CITY OF CANTERBURY BANKSTOWN

STORMWATER SYSTEM REPORT 34 Rose Street, SEFTON NSW 2162

Date: 21-Jul-2021
Ref: WP-SIA-1358/2021
Development type: **Detached Dwelling (single house) & Outbuilding / Pool**

100 yr ARI Flood Extent and Flood Contour Levels (mAHD)
from Duck River Catchment
for 34 Rose Street, Sefton

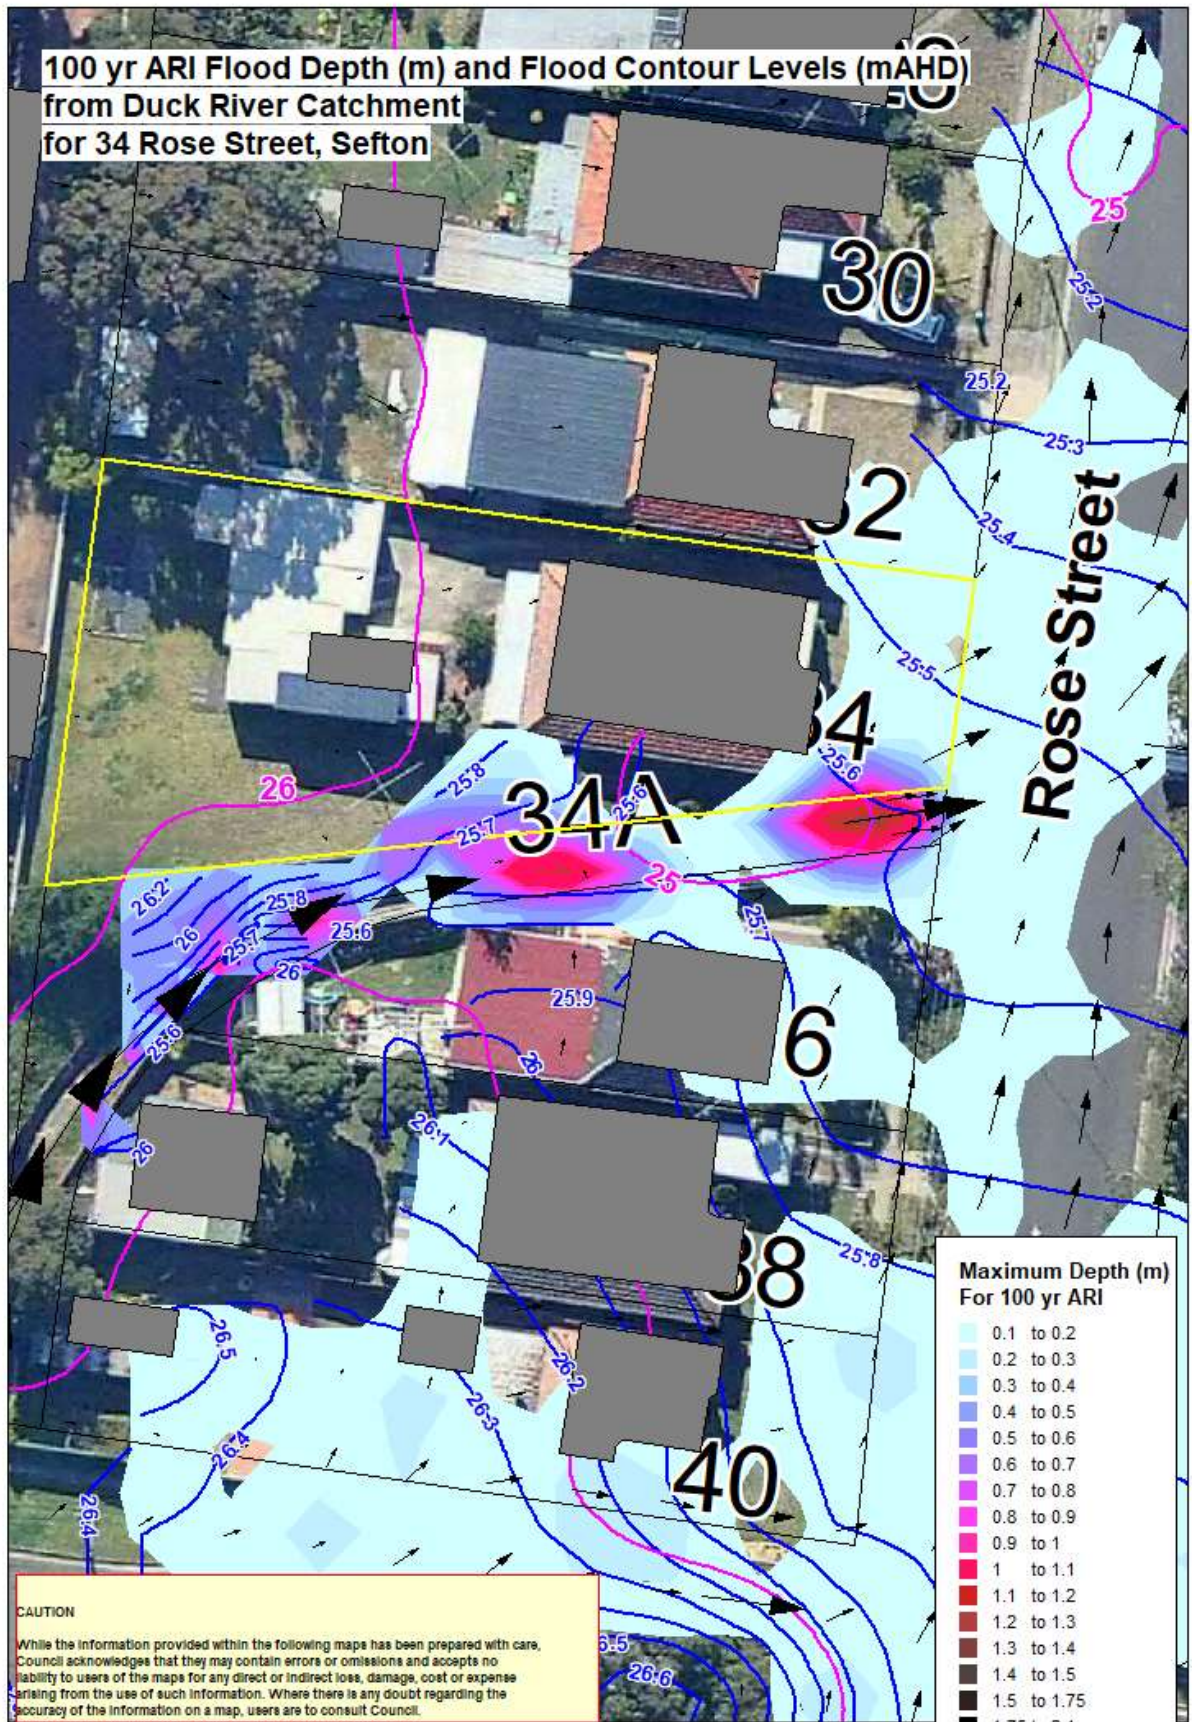
The site will be subject to stormwater inundation from this overland flowpath during large storm events. Refer to the attached "**100 Year ARI Flood Extent Maps from Duck River Catchment Study**" showing the flood contours to m AHD**. Provision should be made on site, and at boundary fences, for this stormwater runoff to pass unobstructed over the site. Stormwater flowing naturally onto the site must not be impeded or diverted.

The estimated 100 year ARI* flood level at the site is RL 25.7 m AHD.**

Habitable floor levels are to be 500mm above the 100 year ARI* flood level at the site adjacent to the proposed buildings.
